CITY OF PORTLAND BUILDING PERMIT

Job ID: 2011-11-2722-HVAC

has permission to Install Trane Roof Top Unit

RE: New Mechanical Unit

PLAN OF TYP OPENING IN ROOF DECK

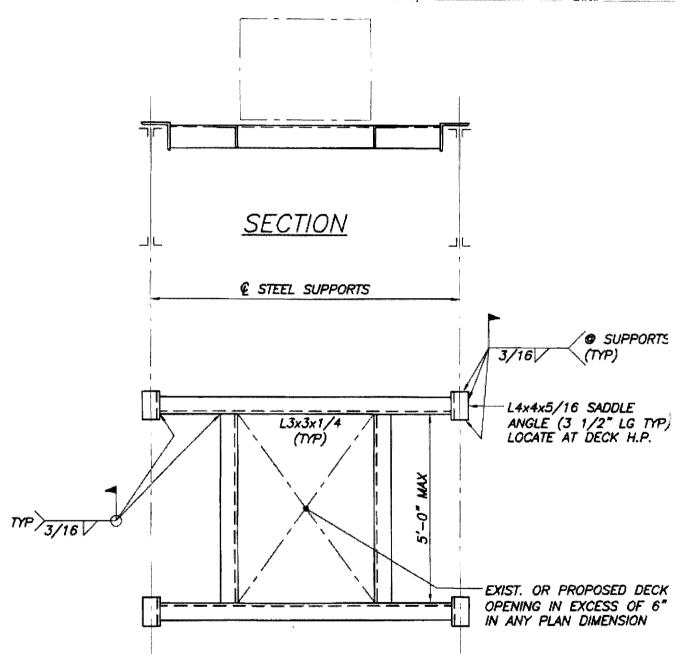
Note that new metal deck penetrations will be necessary for the duct runs. At our visit we noted two existing metal deck penetrations that were not reinforced (photos 1 & 2). Per the requirements of the Steel Deck Institute (SDI), it is our recommendation that all new and existing metal deck openings with any plan dimension in excess of 6 inches be reinforced with a steel angle frame. A typical angle frame detail is attached for reference.

- 1. Equipment shall be installed in compliance with the manufacturer's specifications and the UL listing.
- 2. The openings in the steel deck are required to be reinforced per the structural engineer's recommendations.
